AGENDA
PLANNING AND ZONING COMMISSION MEETING
CITY OF CREVE COEUR, MISSOURI
THURSDAY, APRIL 21, 2022
6:30 PM

NEW BUSINESS**1. Application #22-005: New LED Building and Walkway Lighting for the Bayer East Creve Coeur Campus at 800 Lindbergh Boulevard**

**APPLICATION TO PLANNING AND ZONING COMMISSION
#22-005: NEW LED BUILDING AND WALKWAY LIGHTING FOR THE
BAYER EAST CREVE COEUR CAMPUS AT
800 LINDBERGH BOULEVARD**

Figure 4: Close-up of the detail of the pedestrian lighting

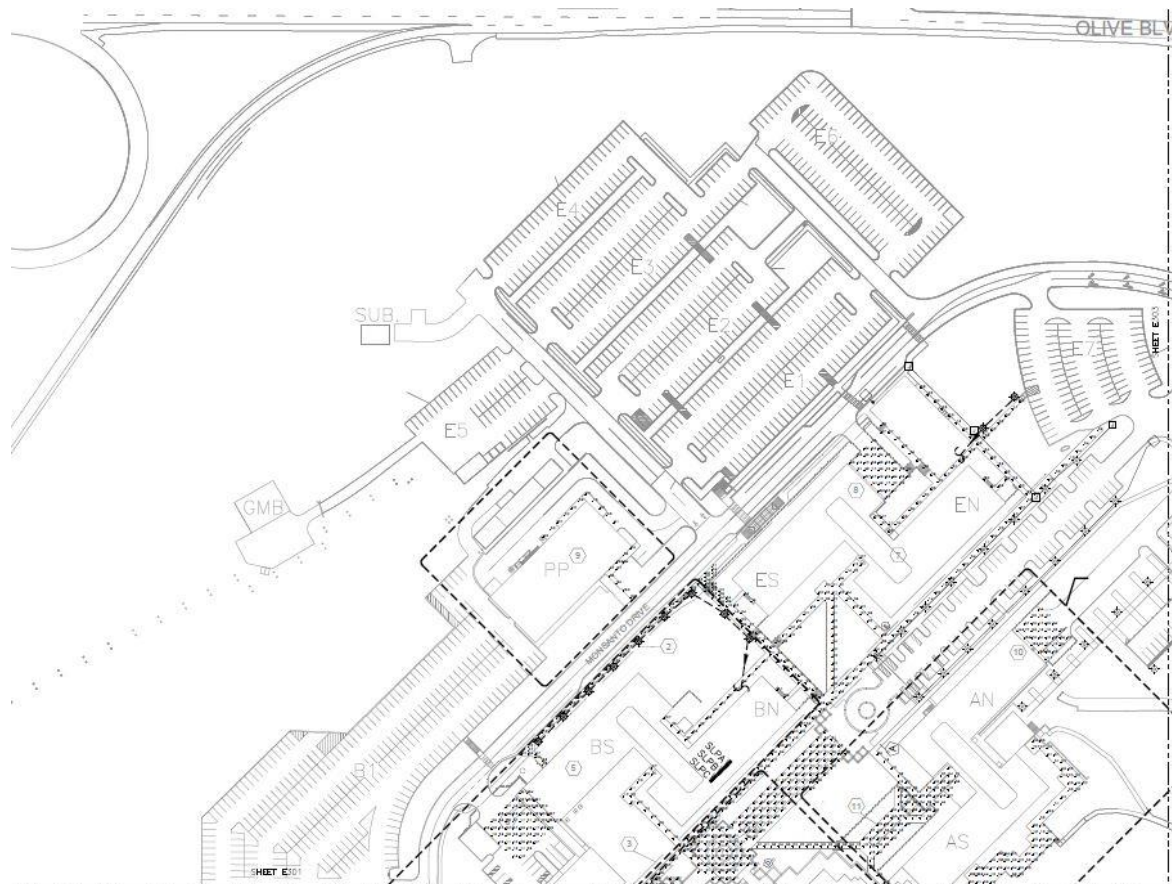
Additionally, subsection (8) of the Lighting section states that sidewalk and pedestrian avenues may be lit by low, bollard-type lighting or as approved by the Planning and Zoning Commission. If reflectors or refractors are used, these devices shall direct light downward and shall meet the cutoff angle criteria. Under no circumstance shall light be directed outward. The proposed pedestrian lighting is approximately 15 feet in height and are internal to the site. The photometric plan indicates that no lighting will not be directed outward or be cast upon adjacent property.

3. The pedestrian lighting shall have a maximum height of 15 feet.
4. No site development plan or minor site plan approval shall be valid for a period longer than twelve (12) months from the date it is approved, unless within such period a building permit is obtained and substantial construction is commenced. Substantial construction shall be deemed to consist of clearing the site, completion of footings, basement or building slab and inspection of such work. The Planning and Zoning Commission and the City Council, when required, may grant extensions not exceeding twelve (12) months each upon written request of the original applicant prior to the expiration of such period and resubmission of the application if the application as resubmitted is substantially the same as the initially approved application. However, the Commission and the Council, as applicable, have the power in such cases to attach new conditions to their re-approval or to disapprove the reapplication. Where the application for re-approval contains changes which the Zoning Administrator concludes materially alter the initial application, the Zoning Administrator shall initiate a new site development plan review procedure as stated in Section 405.1080 or a new minor site plan review procedure as stated in Section 405.1080.

Sheet A-3

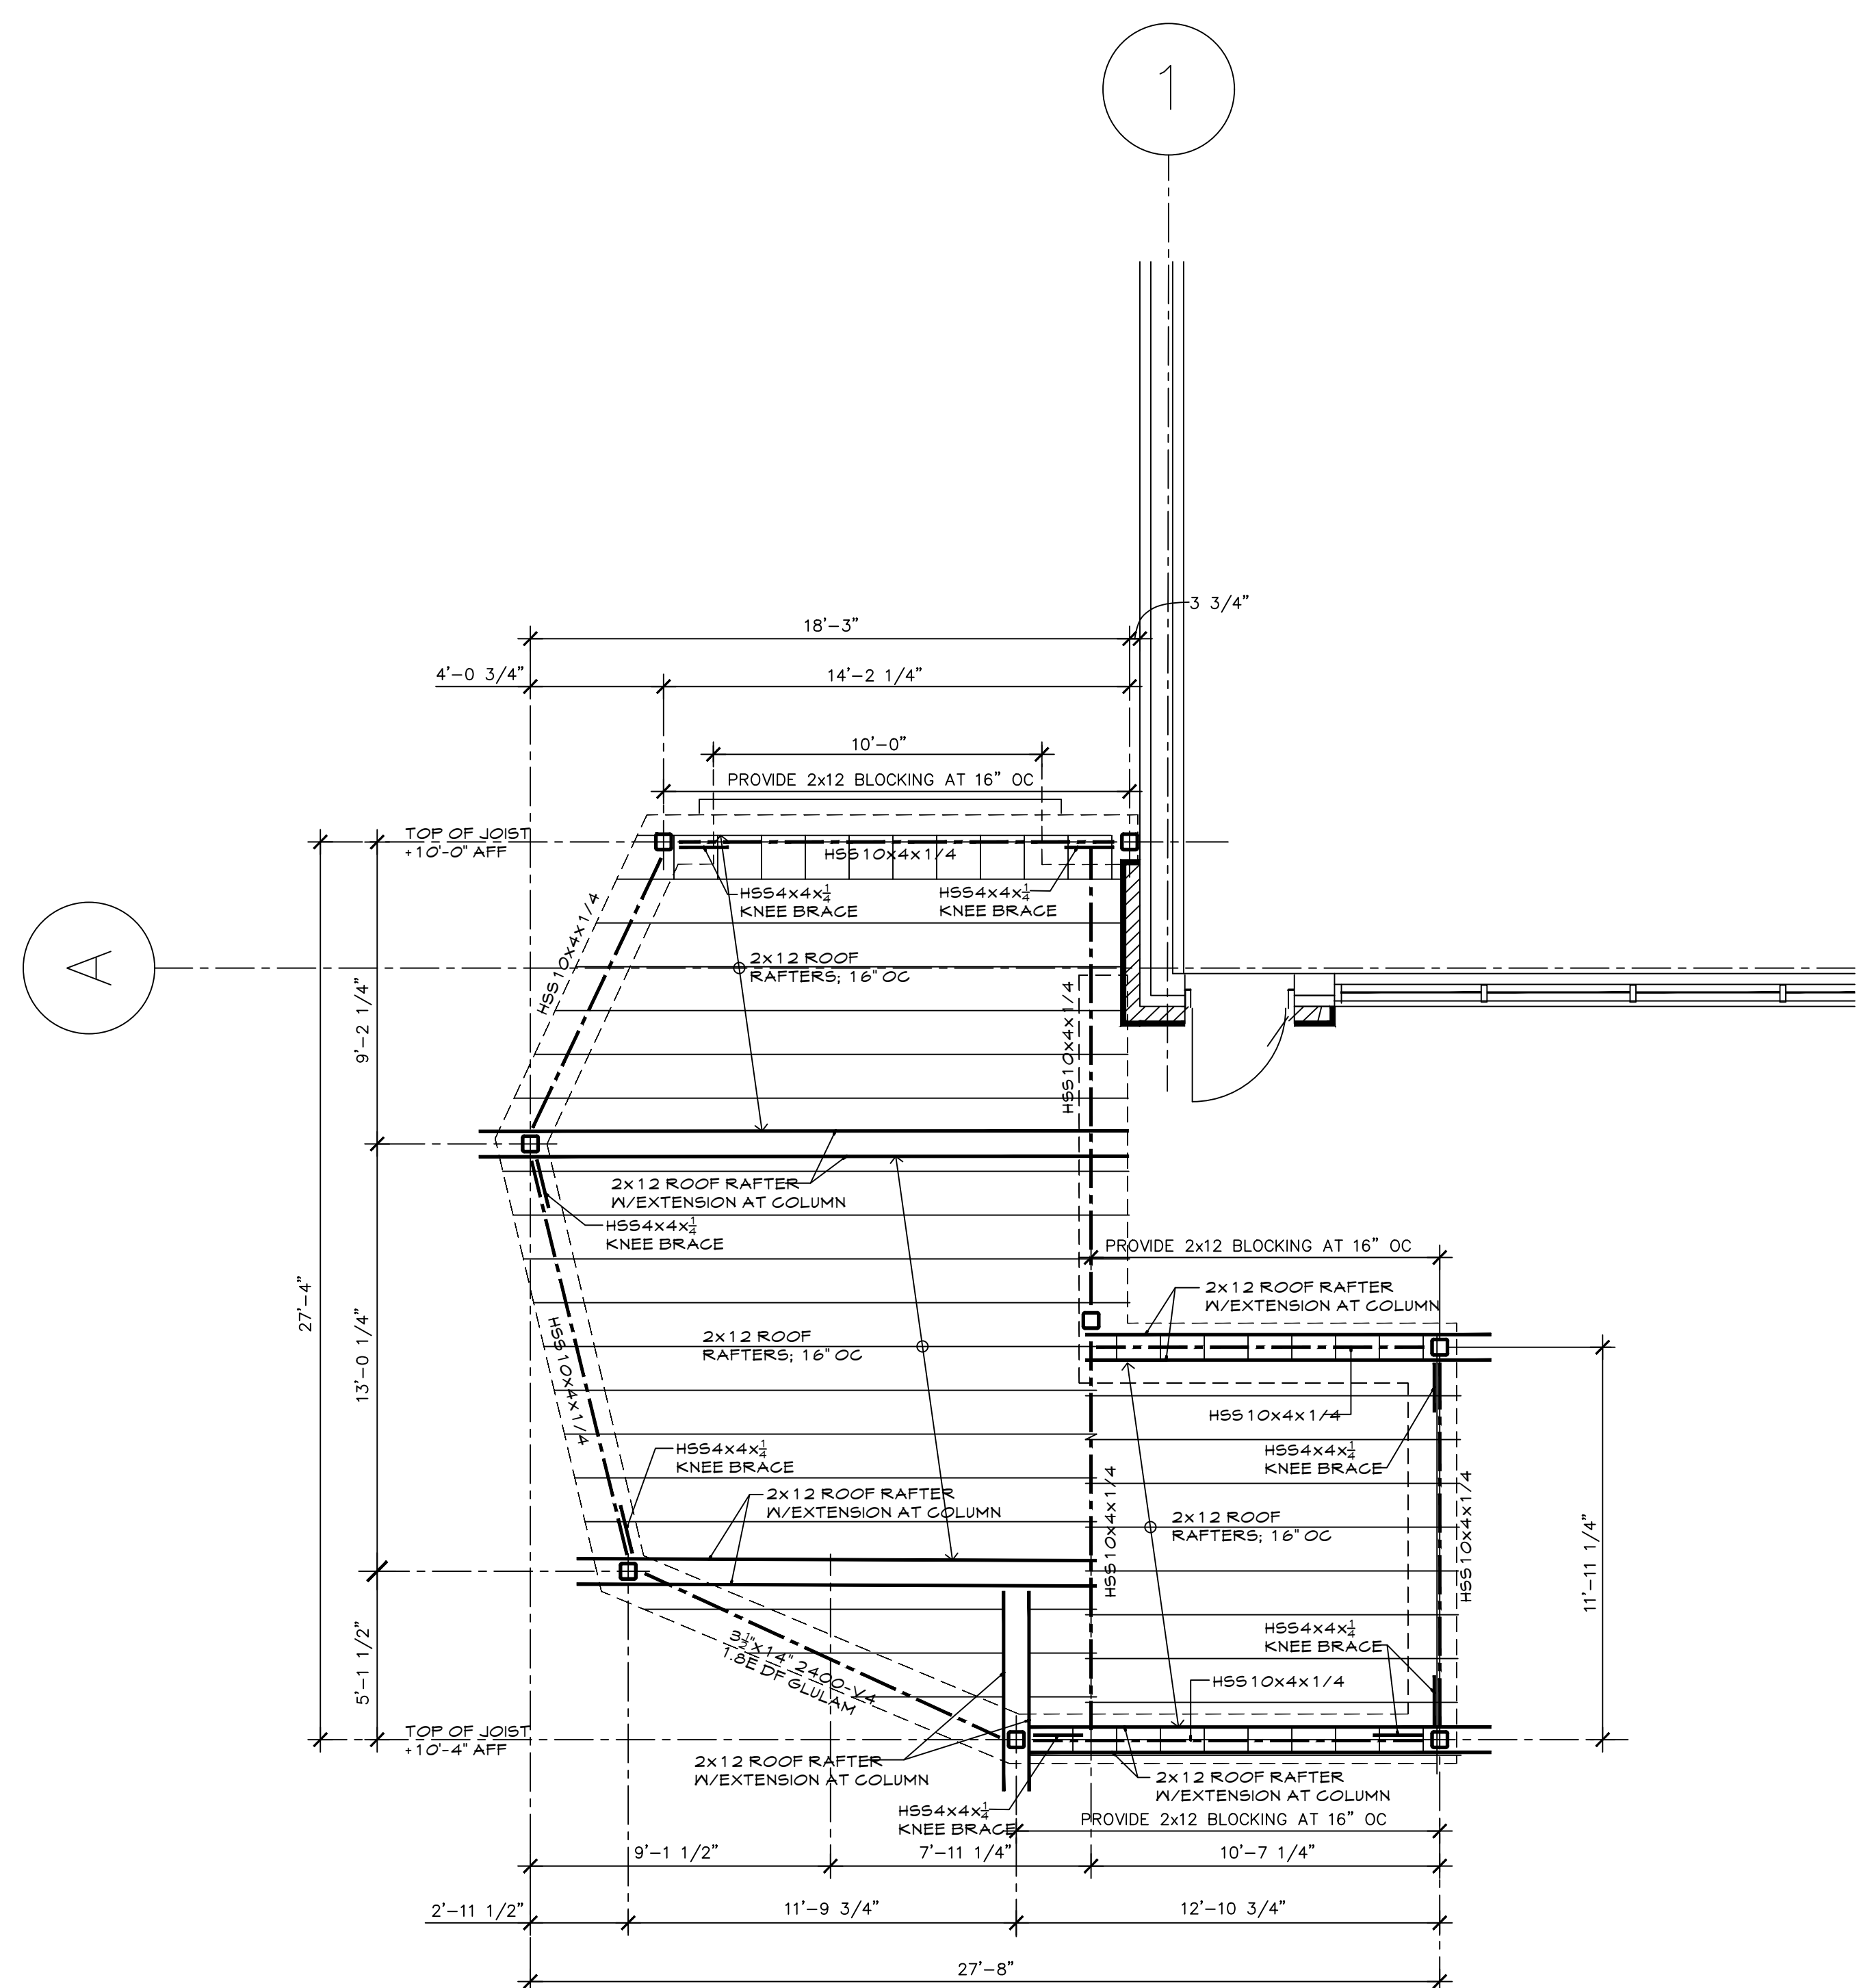
1. Deck steel components will be galvanized steel painted matte black. Railing will be matte black aluminum, and decking and trim will be Trex Composite Spiced Rum.
2. Balusters have been revised to a vertical orientation with less than 4" spacing.
3. General note added to plans on sheet A-3 regarding pressure treated wood requirement.
